SUBJECT: BYRON AND BRAIDWOOD - ISSUANCE OF AMENDMENTS ON SPENT FUEL STORAGE RACKS (TAC NOS. MA5150, MA5149, MA5070, AND MA5071)

The amendments approve the installation of new Boral high density spent fuel storage racks at Byron and Braidwood stations. The amendments also approve an increase in the spent fuel pool storage capacity from 2,870 assemblies to 2,984 assemblies at each station.

SAFETY EVALUATION BY THE OFFICE OF NUCLEAR REACTOR REGULATION  
RELATED TO AMENDMENT NO. 112 TO FACILITY OPERATING LICENSE NO. NPF-37,  
AMENDMENT NO. 112 TO FACILITY OPERATING LICENSE NO. NPF-66,  
AMENDMENT NO. 105 TO FACILITY OPERATING LICENSE NO. NPF-72,  
AND AMENDMENT NO. 105 TO FACILITY OPERATING LICENSE NO. NPF-77  
COMMONWEALTH EDISON COMPANY  
BYRON STATION, UNIT NOS. 1 AND 2  
BRAIDWOOD STATION, UNIT NOS. 1 AND 2  
DOCKET NOS. STN 50-454, STN 50-455, STN 50-456, AND STN 50-457

Figure 3.7.16-1 (page 1 of 1)  
Region 2 All Cell Configuration Burnup Credit Requirements  
(Joseph Oat Spent Fuel Pool Storage Racks)

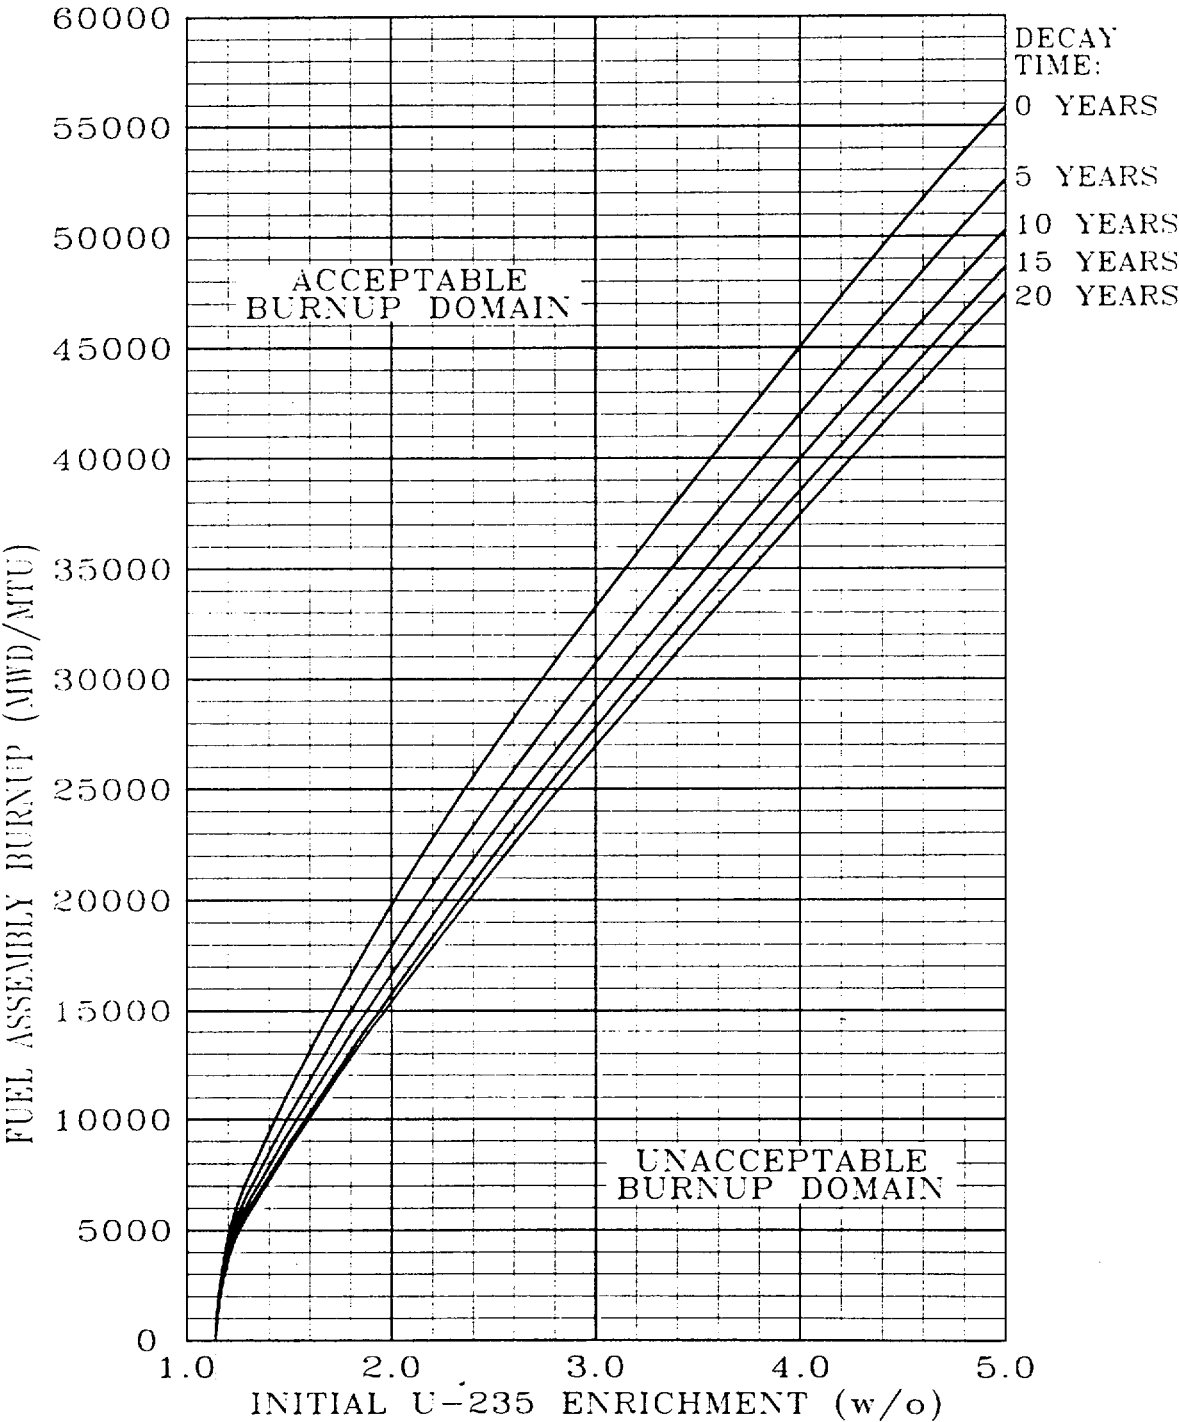
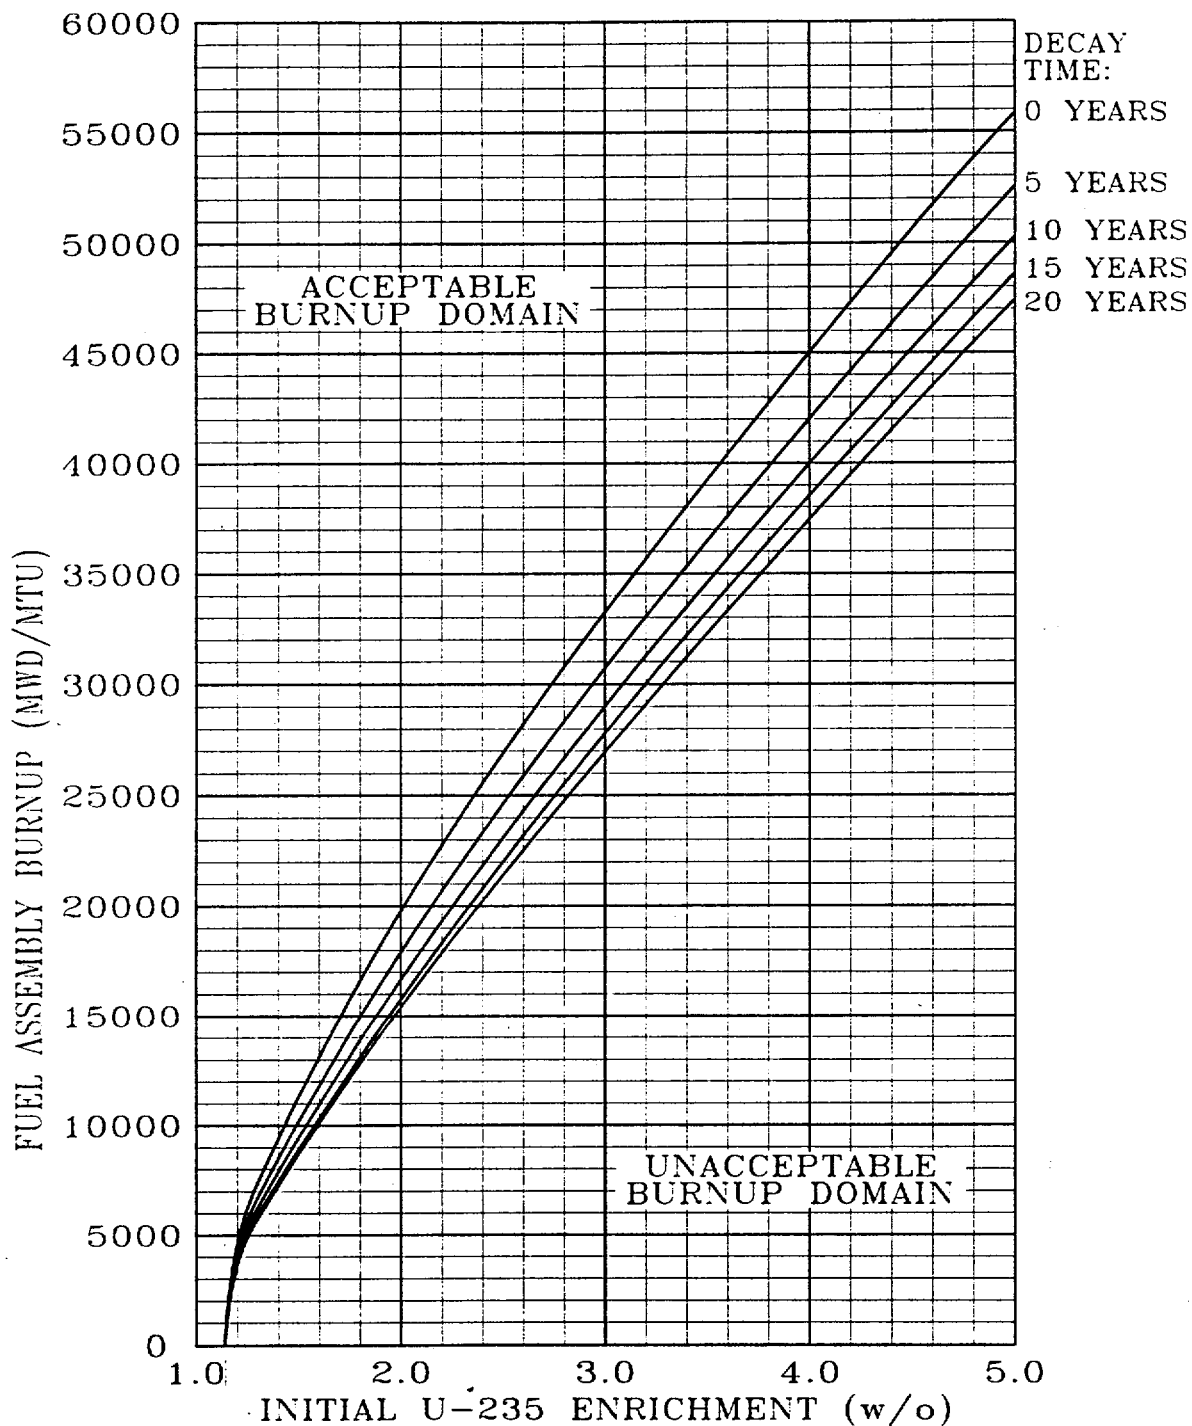
- b. Region 2 of Joseph Oat spent fuel pool storage racks  
Have a combination of initial enrichment, burnup, and decay time within the Acceptable Burnup Domain of Figure 3.7.16-1, 3.7.16-2, or 3.7.16-3, as applicable for that storage configuration.

- b. Region 2 of Joseph Oat spent fuel pool storage racks  
Have a combination of initial enrichment, burnup, and decay time within the Acceptable Burnup Domain of Figure 3.7.16-1, 3.7.16-2, or 3.7.16-3, as applicable for that storage configuration.

Figure 3.7.16-4 (page 1 of 1)  
Region 2 Fuel Assembly Burnup Requirements  
(Holtec Spent Fuel Pool Storage Racks)

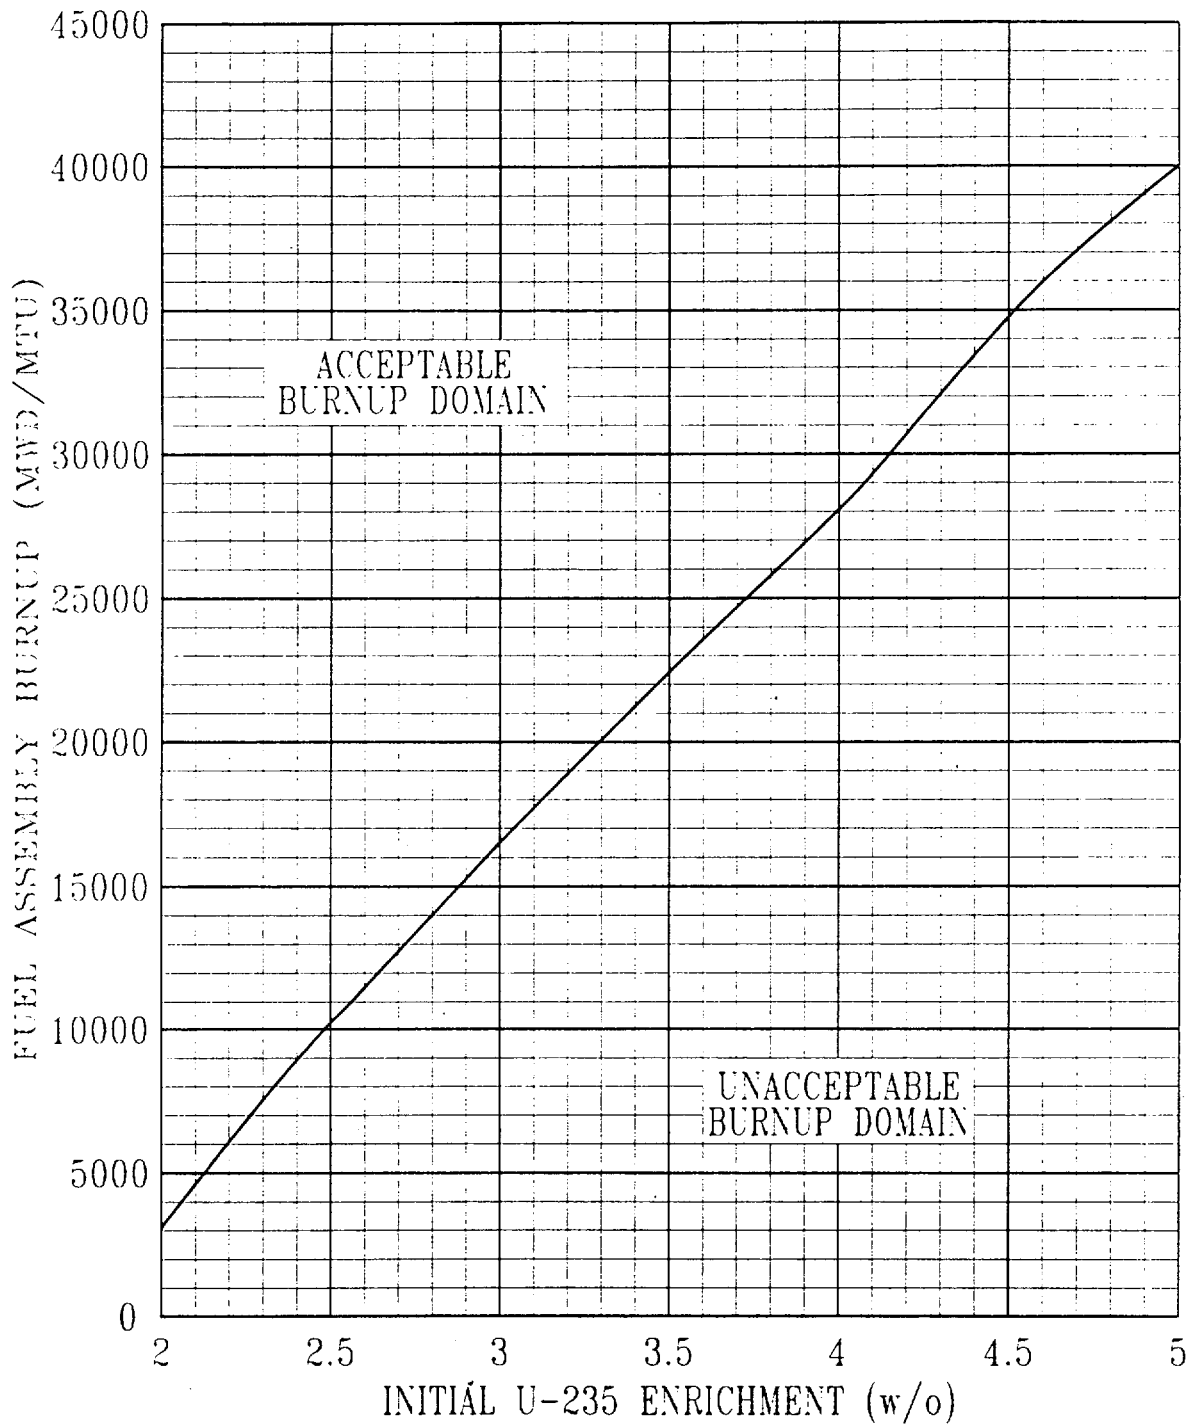
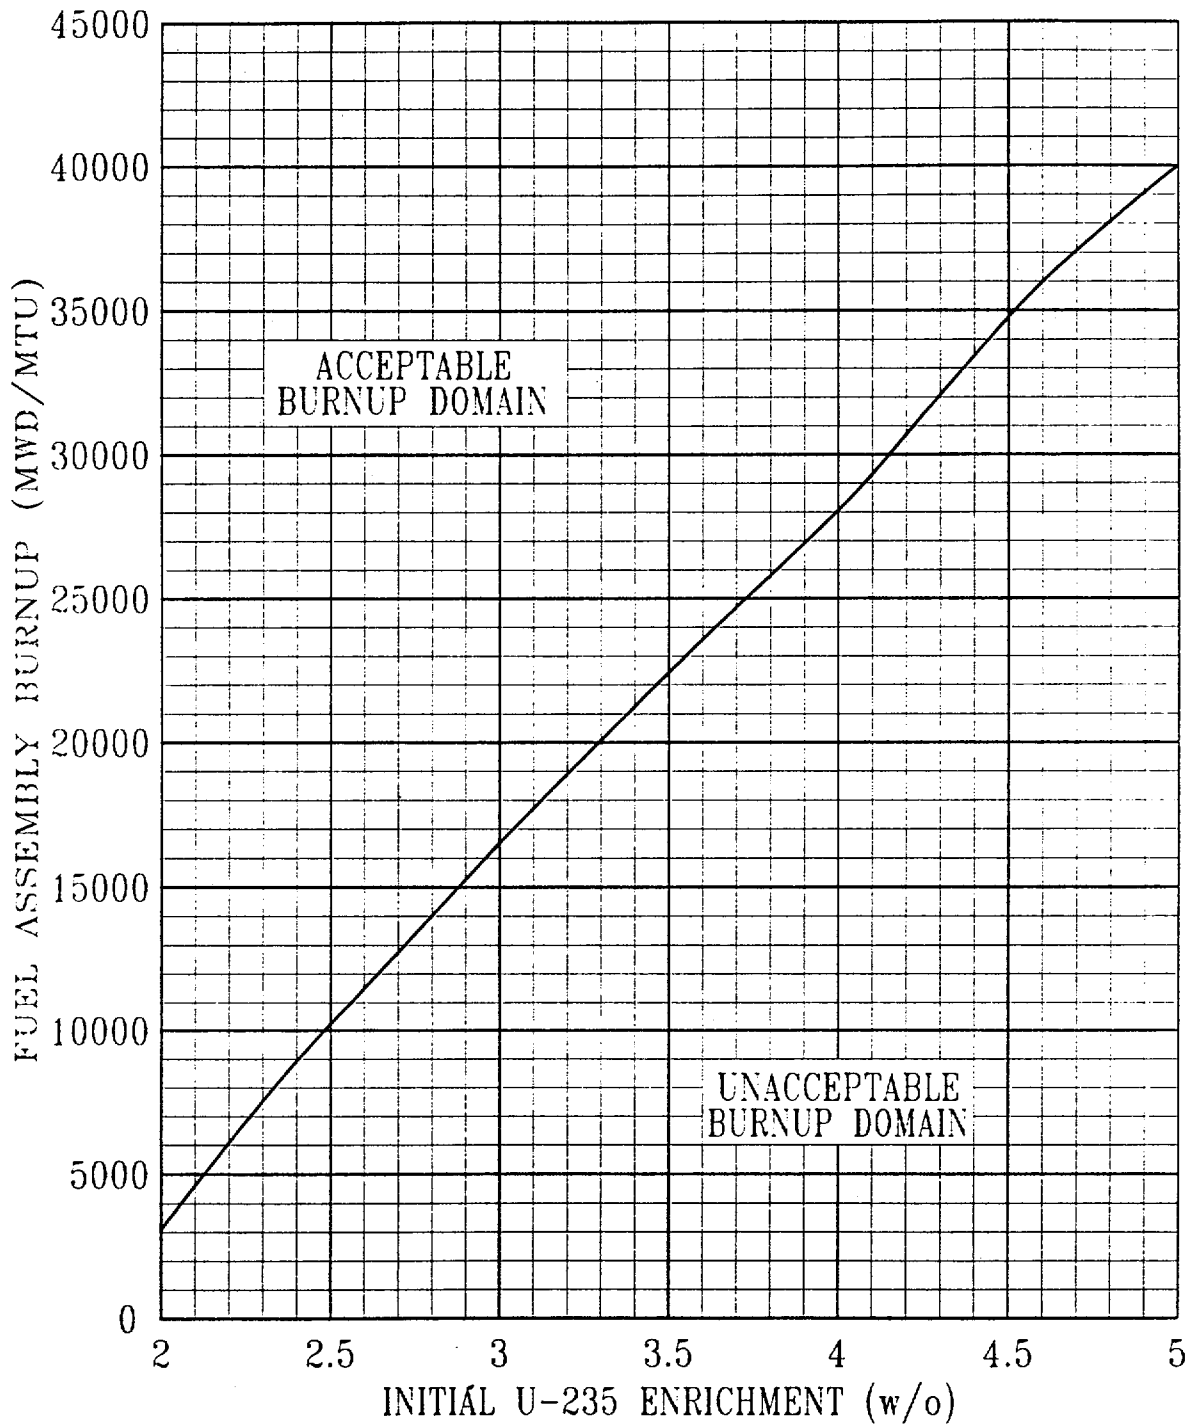
- e. Region 2 of Holtec spent fuel pool storage racks  
Have a combination of initial enrichment and burnup within the Acceptable Burnup Domain of Figure 3.7.16-4.

- e. Region 2 of Holtec spent fuel pool storage racks  
Have a combination of initial enrichment and burnup within the Acceptable Burnup Domain of Figure 3.7.16-4.

The results of these analyses, using the acceptable methods discussed above, meet the NRC criterion of  $k_{eff}$  no greater than 0.95, including all uncertainties at the 95/95 probability/confidence level, and are, therefore, acceptable. The results show that Region 1 can accommodate fuel with enrichment as high as 5.0 w/o U-235 without restriction. Storage of fuel assemblies in Region 2 requires fuel burnup as a function of initial enrichment as given in TS Figure 3.7.16-4.

burnup and enrichment combination outside of the acceptable areas in TS Figure 3.7.16-4, which could lead to an increase in reactivity. For such events, credit may be taken for the presence of at least 300 ppm of soluble boron in the pool required by TS 3.7.15 for the Holtec racks, since the staff does not require the assumption of two unlikely, independent, concurrent events to ensure protection against a criticality accident (double contingency principle). The reduction in  $k_{eff}$  caused by the boron more than offsets the reactivity addition caused by credible accidents. In fact, calculations show that for the most severe accident condition, a soluble boron concentration of 220 ppm boron would be adequate to maintain  $k_{eff}$  less than 0.95 for the Holtec racks.
